Historic Preservation Board

Wednesday, February 7, 2024 at 5:00 PM
Room 24, Basement Level of City Hall
and Via Zoom

TO: Chair O'Brien and Members of the Historic Preservation Board
FROM: Rob Wiener, Historic Preservation Compliance Coordinator
DATE: February 2, 2024
RE: 106 Pine Street - PUBLIC HEARING – Add Basement Access Door and Stairs
PROJECT ID: HPBR-002605
MEETING: February 7, 2024

**STAFF MEMORANDUM
HISTORIC PRESERVATION PROGRAM
PLANNING AND URBAN DEVELOPMENT**

DETAILS

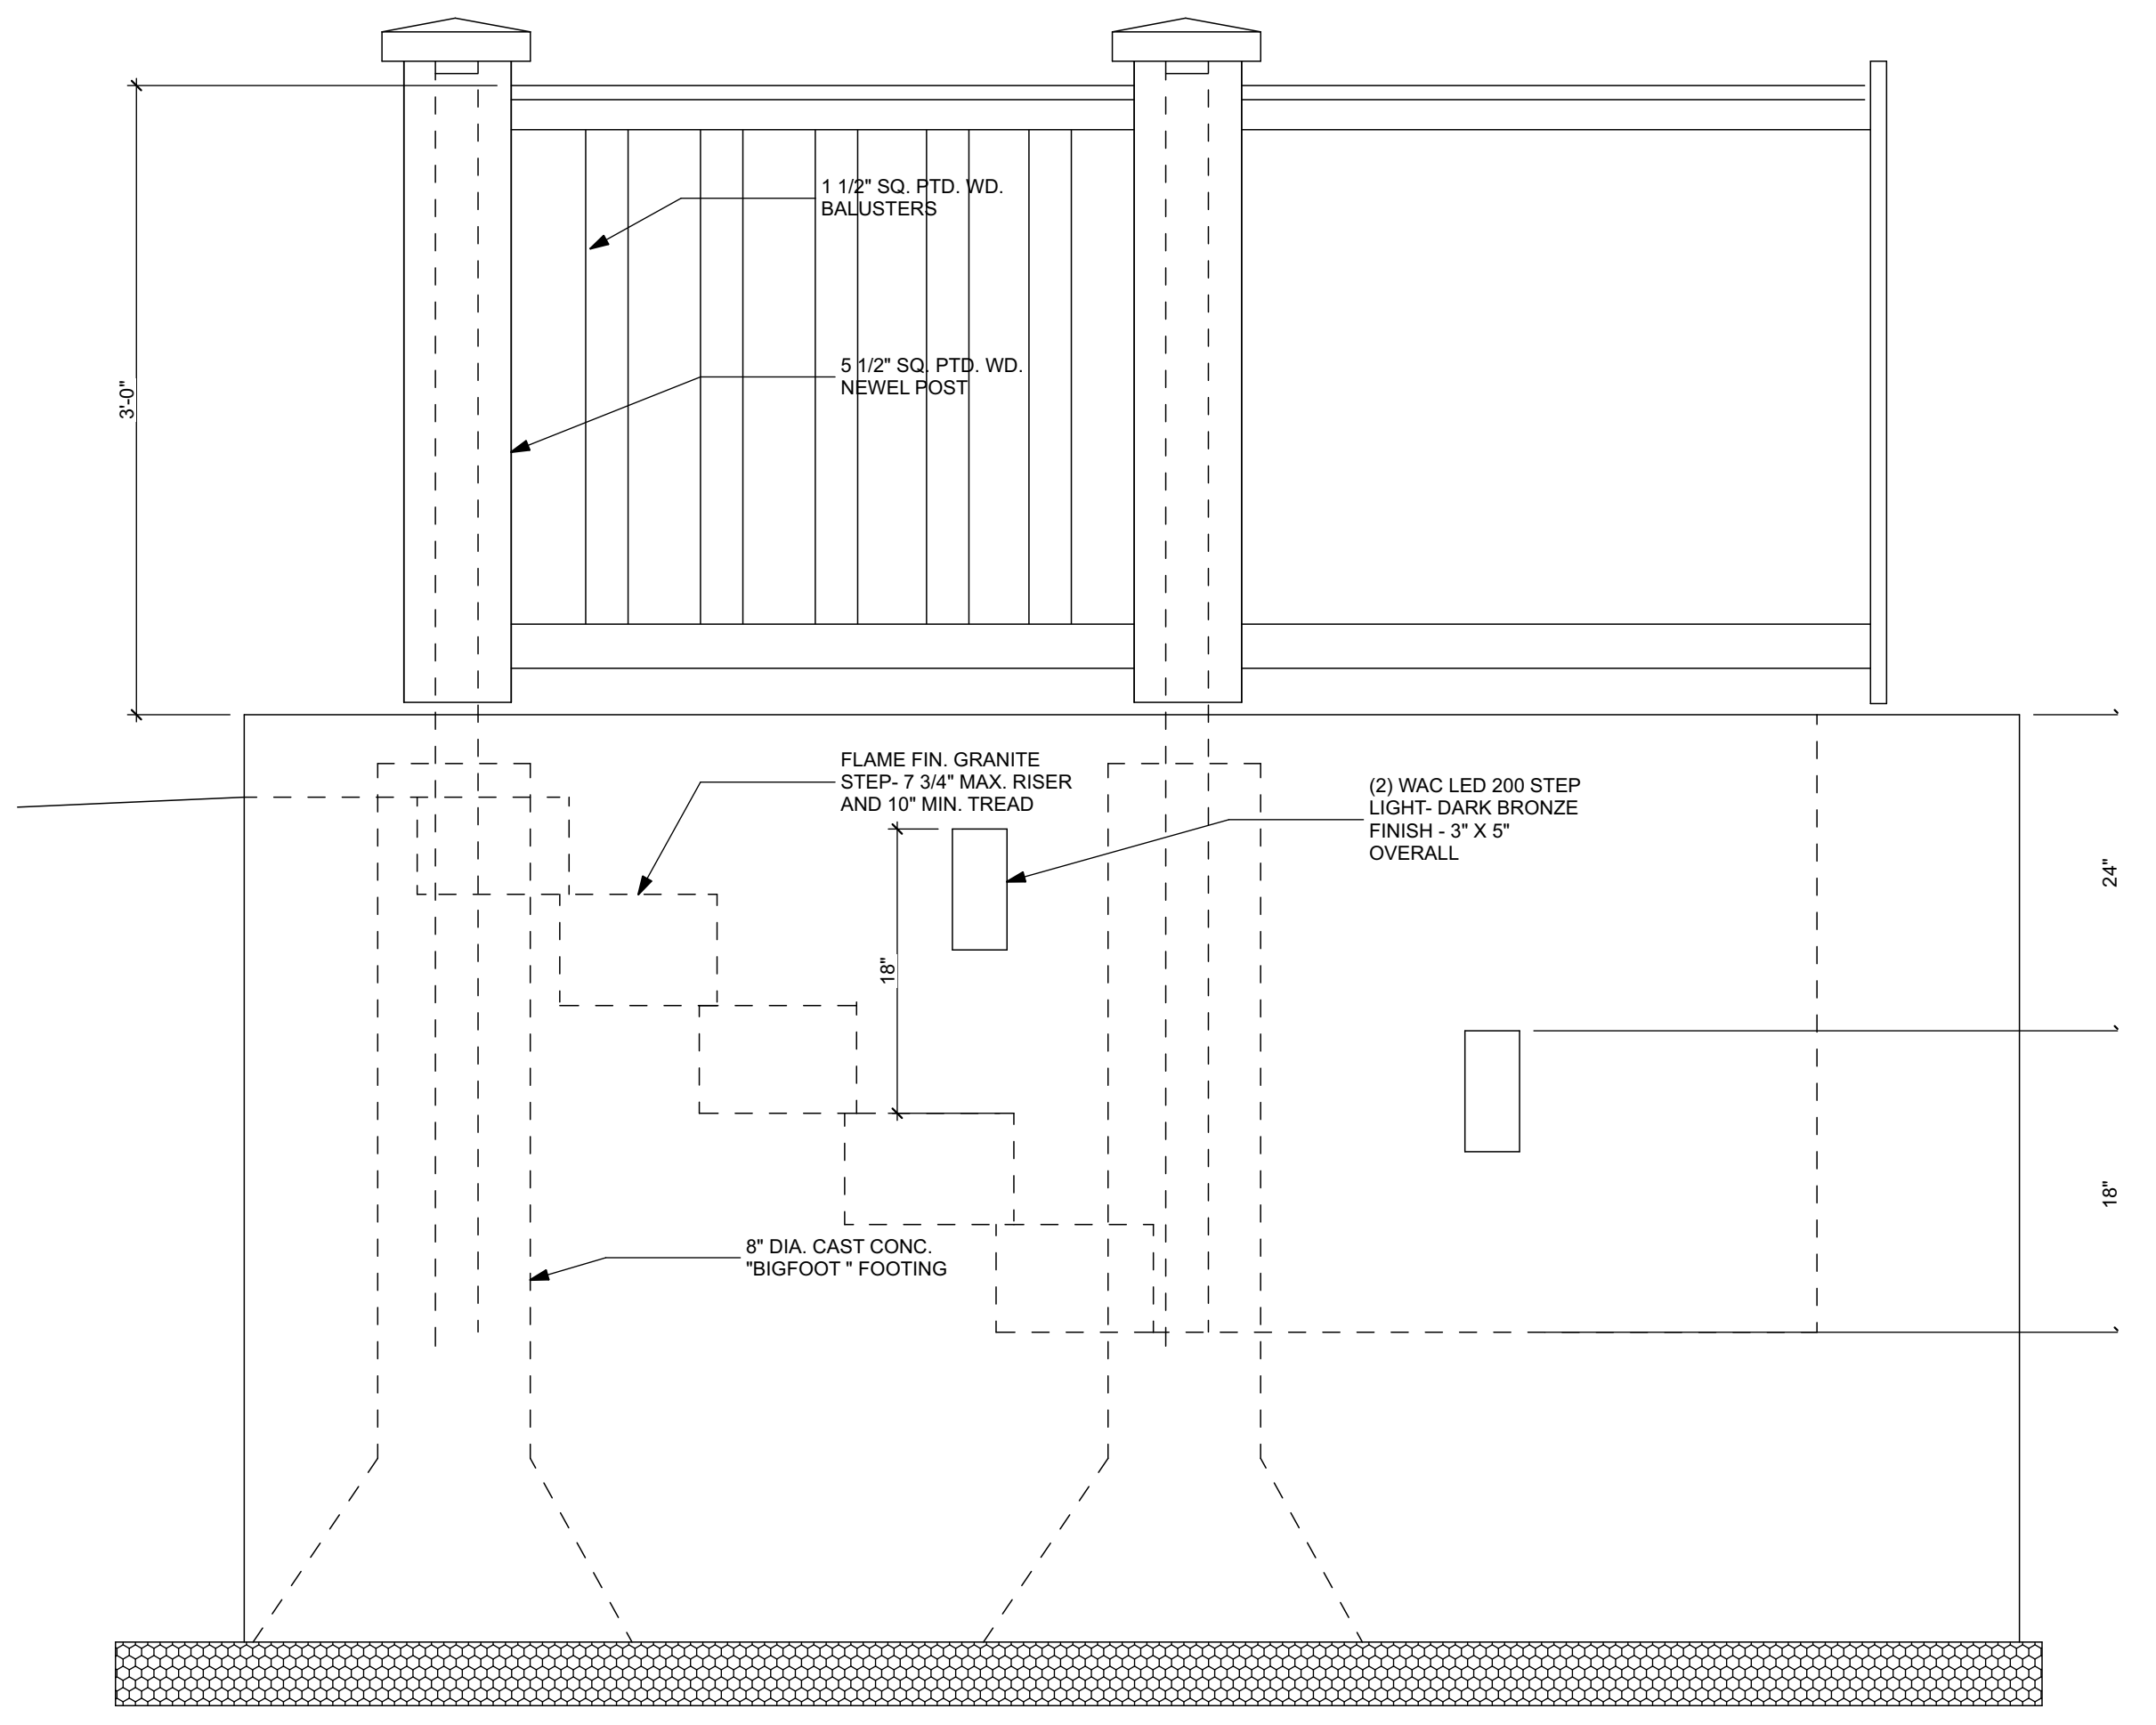
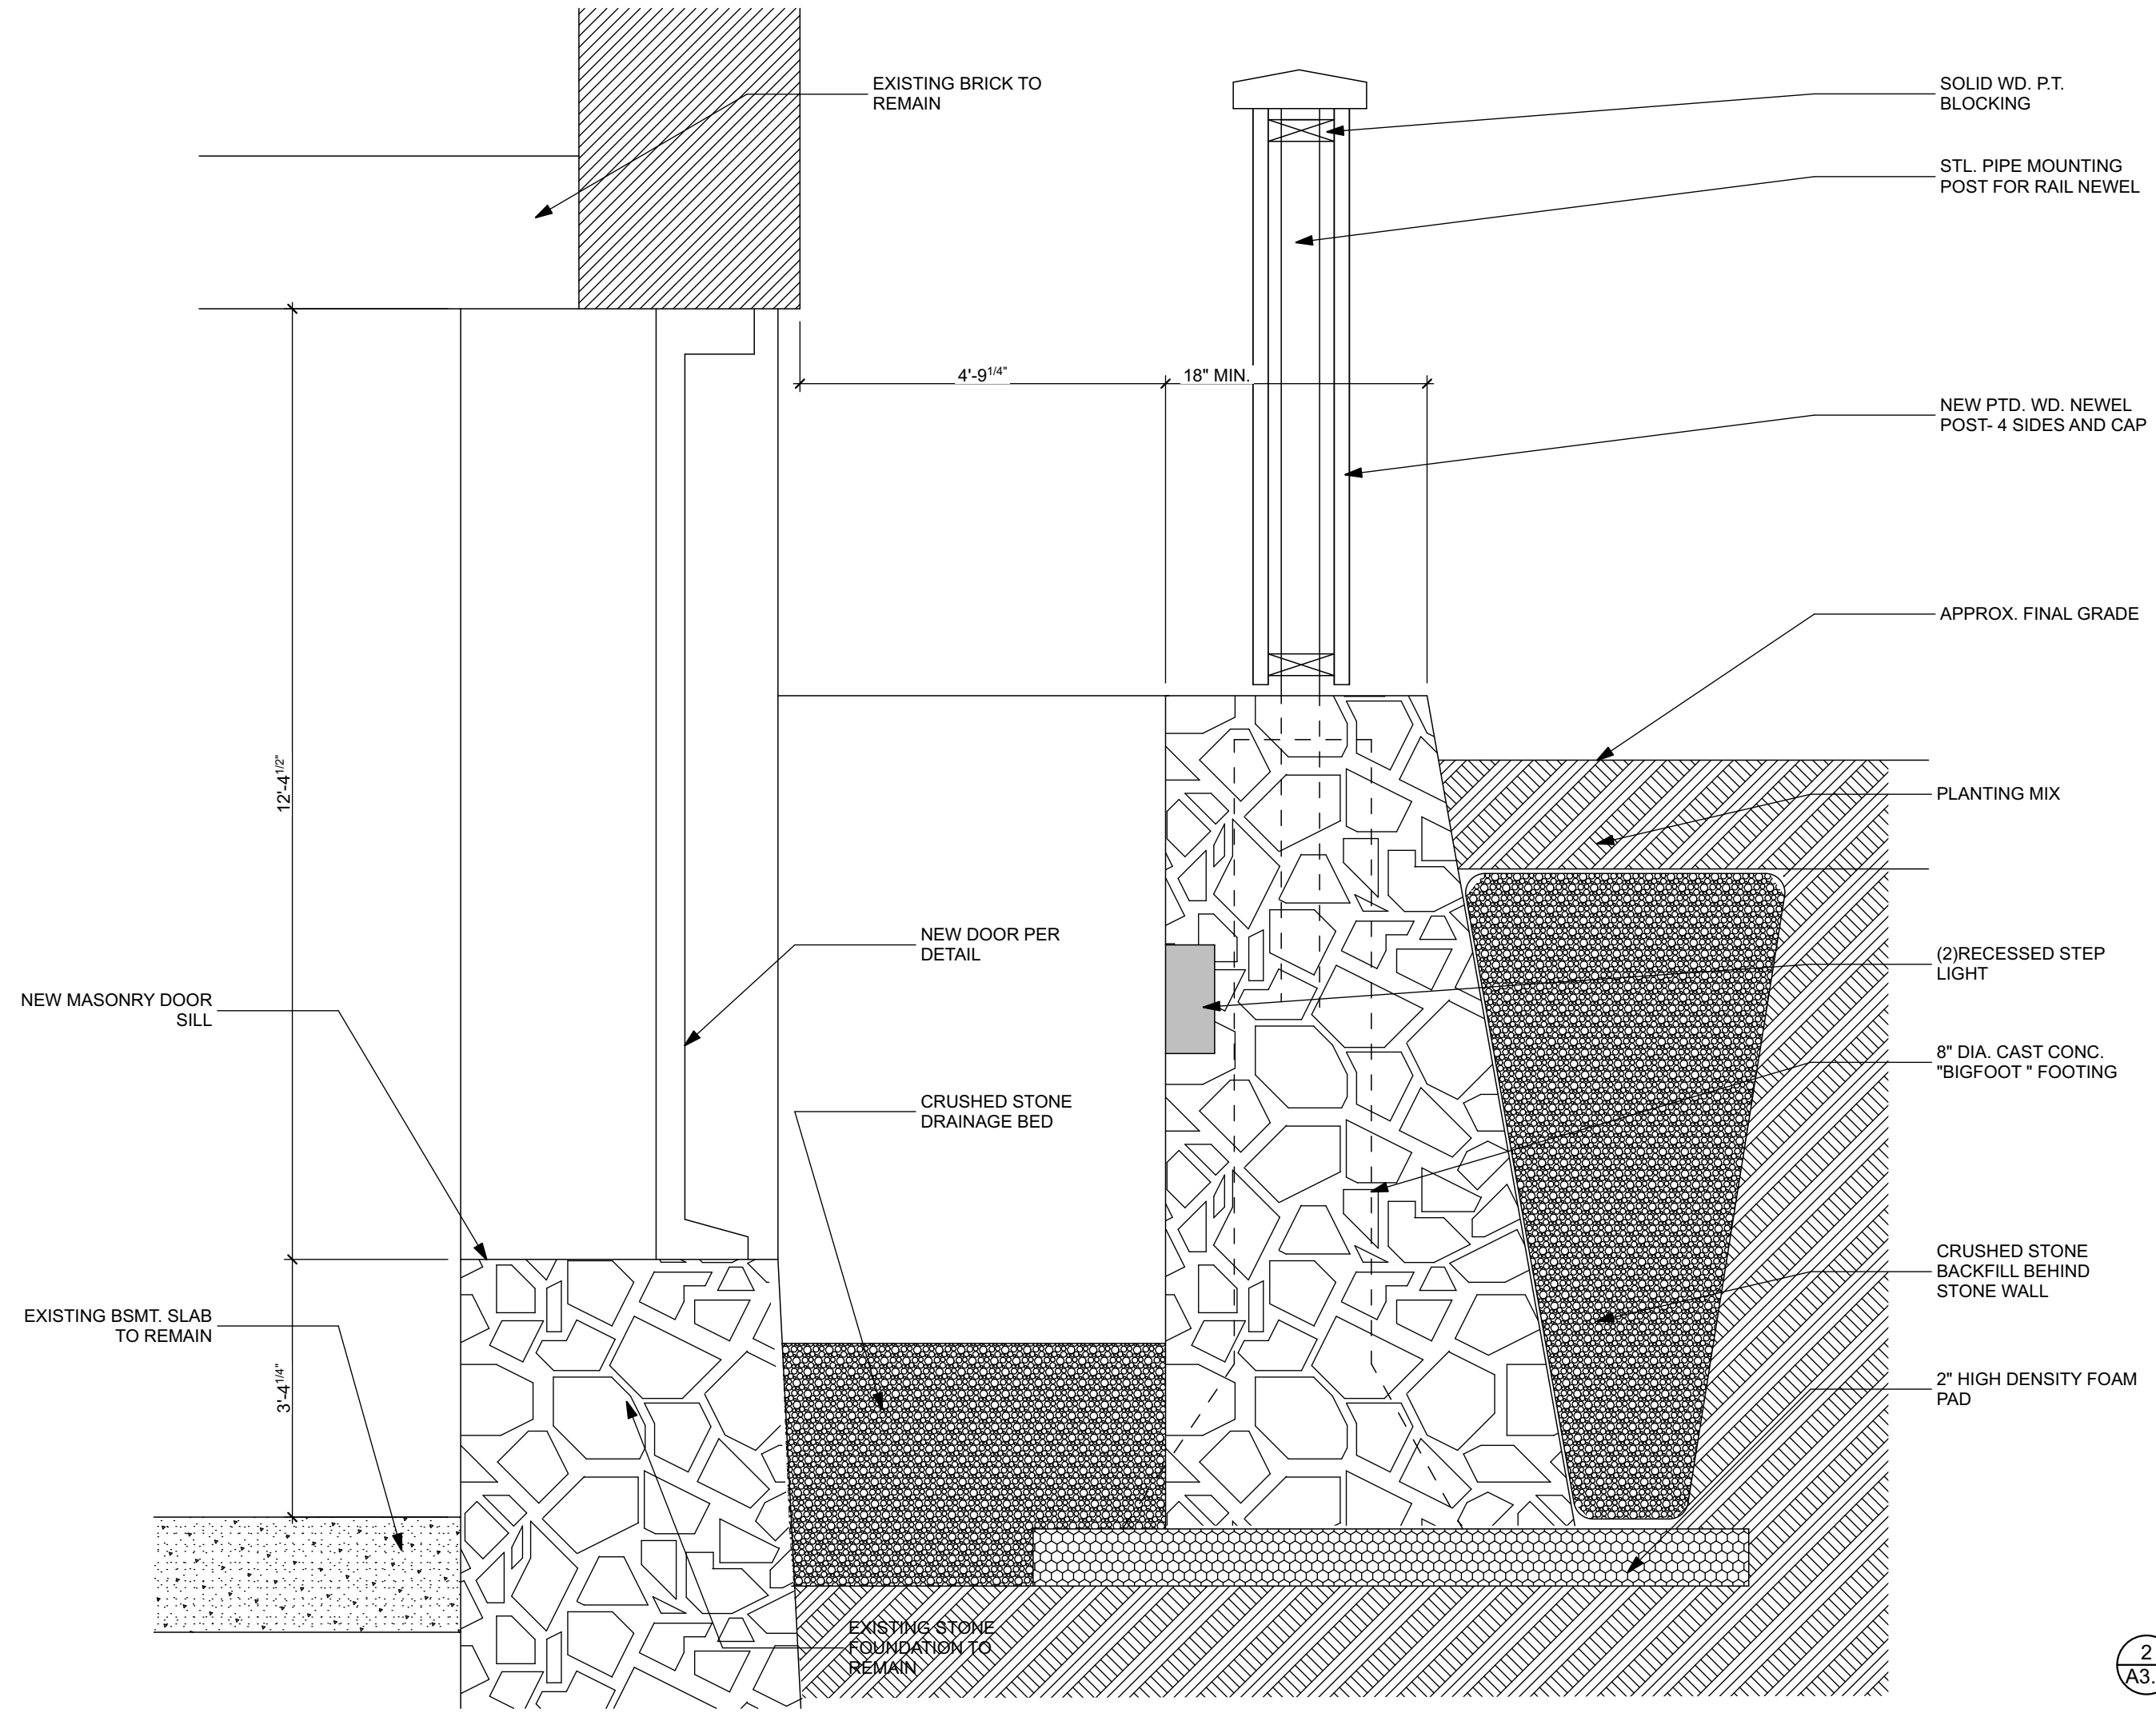
- Please provide details on lighting, handrail for the stairs, and the guard rail at grade.
- It was recommended that the visible guardrail should be a painted wood, traditional balustrade compatible with the nearby existing porch.
- Also recommended was enhancement of the garden path landing at the top of the stairs.

The proposed access stair will have flame faced granite treads and stacked stone retaining walls. Footings and piers are located/ hidden within the wall to anchor the posts for the proposed guard. We hope to work with Libby Masonry, who has visited the site. They felt that the small area of exposed existing foundation can be reworked with new stone for a consistent look. The guard will be painted wood as detailed and are designed to match the existing porch railings.

The proposed wall mounted painted metal handrail will be based upon aluminum profiles by King Metals. The graspable run will have a volute detail welded at each end. Two aluminum wall brackets will be provided. The aluminum will minimize corrosion/ staining and hold paint well.

The stair well will be lit with two step lights recessed into the stone wall. They are 3" x 5" and have dark bronze housings with full cutoff lights. The lights are located to be minimally visible from the sidewalk and to provide low level intensity.
